**Re: Minor Project Refinement No. 2 for the South Orange County Reliability Enhancement Project.**

## South Orange County Reliability Enhancement Project CPUC Minor Project Refinement Form

**MPR-2 FIGURE 1  
RECLAIMED WATER WHARF  
WORK AREA**

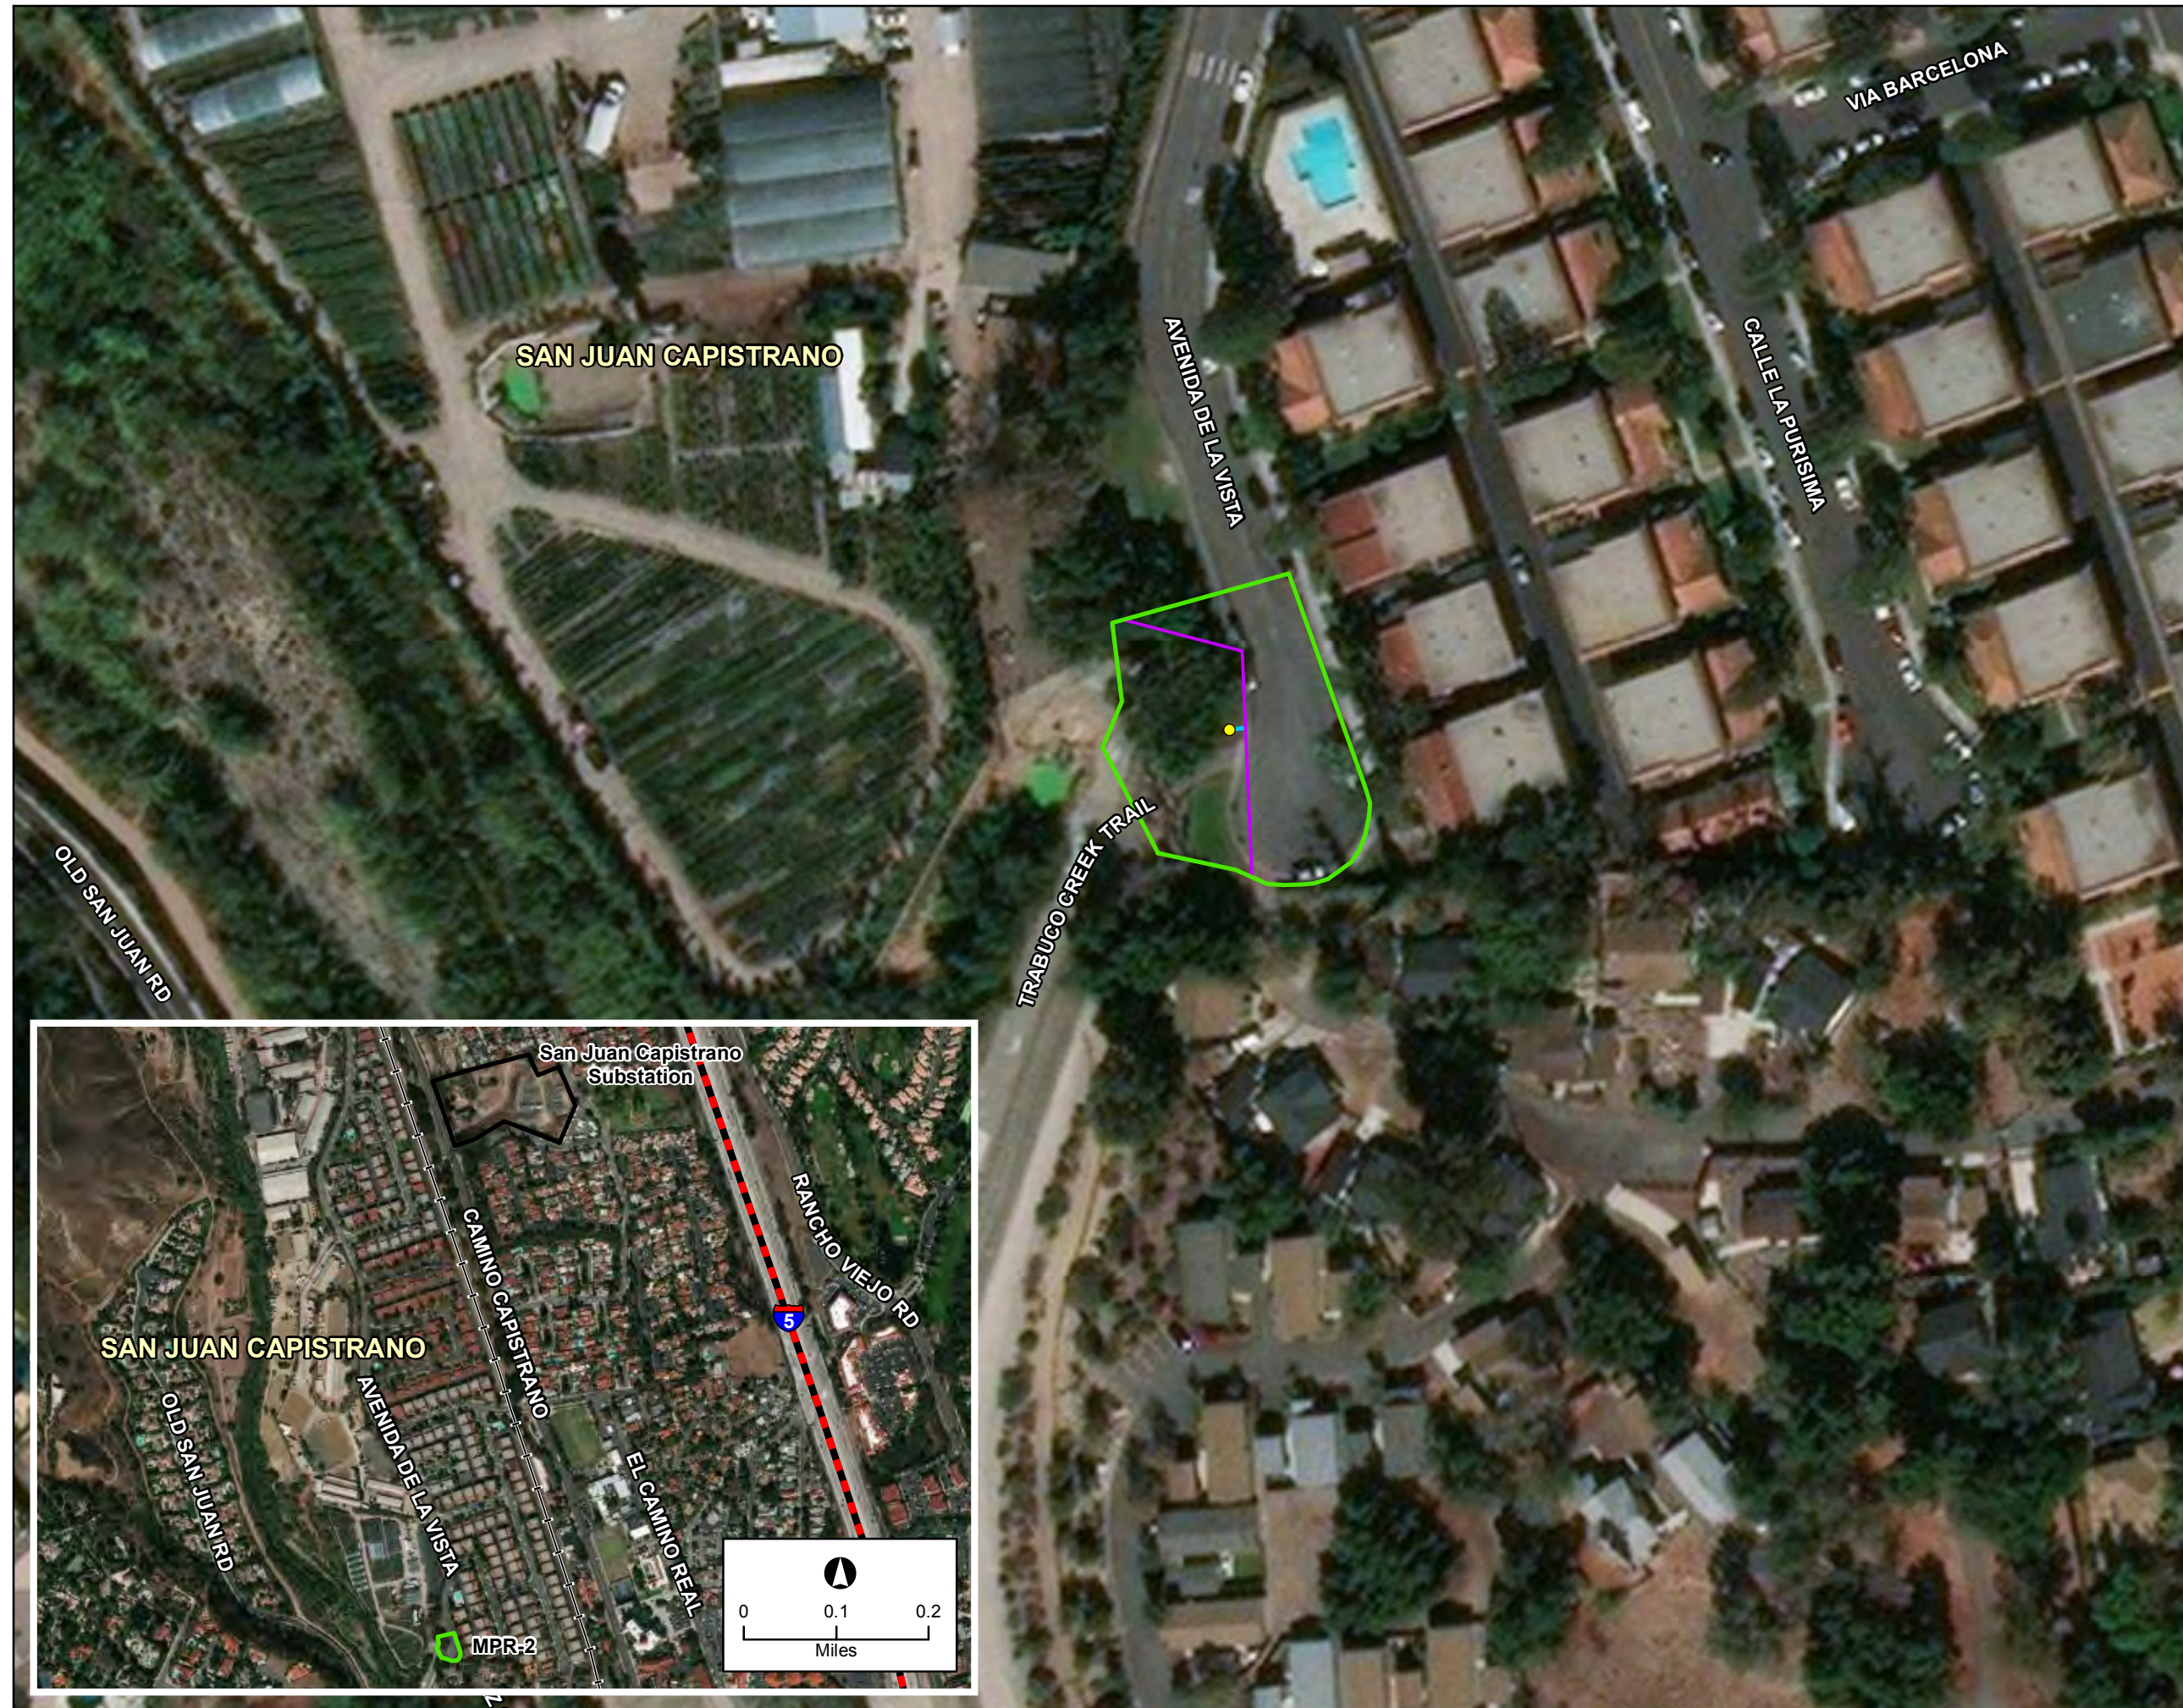
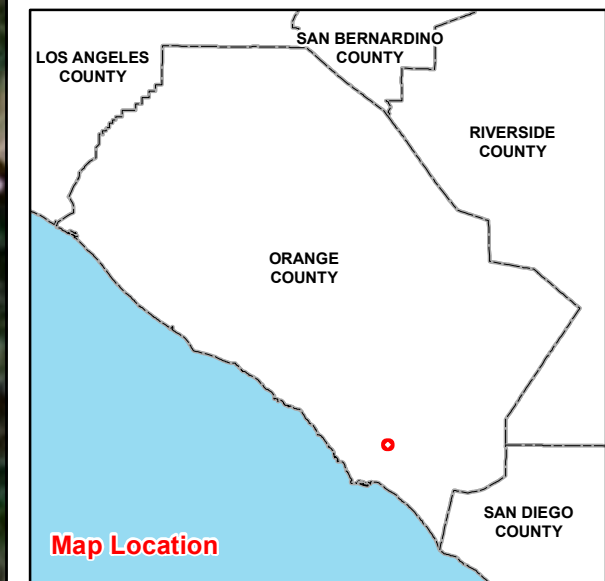
SDG&E is requesting approval of MPR-2 for a new temporary work area required for the installation of a reclaimed water hydrant that will be used continuously to provide reclaimed water during site development activities at the Capistrano Substation. The reclaimed water hydrant will be located at the end of the cul-de-sac on Avenida de la Vista, near the entrance to the Trabuco Creek Trail (refer to Attachment B, MPR-2 Figure 1 and Attachment C, MPR-

2 Site Photographs). The total work area is approximately 15,460-square feet (0.359 acre), with only approximately 16 square feet of ground disturbance associated with installation of the hydrant and trenching to the existing water pipeline. The majority of the work area will be located within the City of San Juan Capistrano public right-of-way and the hydrant will be located on City property (De la Vista Park).

Installation of the reclaimed water hydrant will require trenching within Avenida de la Vista to tap into the existing reclaimed water line. A lateral pipe will be installed within the trench and connected to a hydrant located on the west side of the road. A hi-line or firehose will be connected to the hydrant and extended to the area to the south (near the entrance onto the Trabuco Creek Trail) where water trucks will park while filling with reclaimed water. The installation of the reclaimed water hydrant will take approximately 5 to 7 days and will require the use of a single 580 back hoe and various hand-held tools to complete the work. Ground-disturbing activities will be limited to the area designated for trenching as shown on Figure 1. The area designated as MPR-2 Temporary Work Area (also shown on Figure 1) will only be used for construction access, parking and staging (requiring no ground disturbance). MPR-2 work activities will not require vegetation or tree removal and SDG&E does not anticipate that the work will require the complete closure of public roadways, trails or parks. However, SDG&E will comply with City permit requirements once issued. Upon completion of the reclaimed water hydrant, the trench will be backfilled and repaved to pre-Project conditions. The reclaimed water hydrant will be permanently left in place as an additional hydrant for the City.

- Maps & Figures: Refer to **Attachment B, Figure 1**, for a map of the MPR-2 proposed work area. Refer to **Attachment C, MPR-2 Site Photographs**, for pictures of the current conditions within the MPR-2 temporary work area.
